# UNITED STATES PATENT AND TRADEMARK OFFICE

APPLICATION NO.	FILING DATE	FIRST NAMED INVENTOR	ATTORNEY DOCKET NO.	CONFIRMATION NO.
10/747,669	12/29/2003	Fusasuke Gotoh	KAM 17.895B (100799-00090	1565
26304	7590 07/31/2006		EXAMINER	
KATTEN MUCHIN ROSENMAN LLP 575 MADISON AVENUE			JOYCE, WILLIAM C	
NEW YORK, NY 10022-2585			ART UNIT	PAPER NUMBER
			3682	
		DATE MAILED: 07/31/2006

#### **DETAILED ACTION**

This Office Action is in response to the amendment filed May 15, 2006 for the above identified patent application.

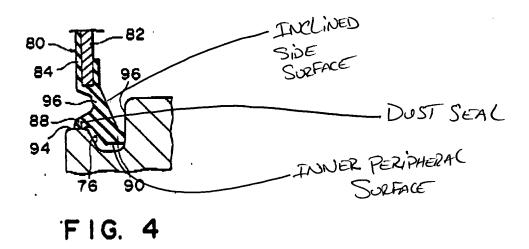
Uchida et al. illustrates in Figure 4 a seal as shown below. The seal having an inclined side surface opposing a wall surface of a seal groove, an inner peripheral surface located radially inward of the inclined side surface and opposing a bottom surface of the seal groove, a continuation portion for continuously connecting the inclined side surface with the inner peripheral surface, the continuation portion being in sliding contact with the seal groove, the angle between the wall surface of the seal groove and the inclined side surface being in a range from 10 degrees to 45 degrees, the inner peripheral surface of the seal being parallel to the bottom of the seal groove. Note the Figure below.

As described above, Uchida et al. discloses in Figure 4 a seal having the features defined by claim 5, but Figure 4 does not appear to show the continuation portion being formed an a curved surface defining an arch shape in cross section. It was known in the art to form the portion of a lip seal that engages a bearing race as a curved arch shaped surface. For example, Figure 2 of Uchida et al. illustrates the portion of the seal (6) that engages a side wall (38) of a seal groove as a curved arch shaped surface. It would have been obvious to one of ordinary skill in the art at the time the invention was made to form the continuation portion illustrated in Figure 4 of Uchida et al. with a curved arch shaped surface, as illustrated in Figure 2 of Uchida et al., motivation being to reduce the contact surface between the relatively moving components.

With respect to claim 5, Uchida et al. illustrates a dust seal lip (88) located on the outside of the inner peripheral edge and facing the outer peripheral surface of the inner race.
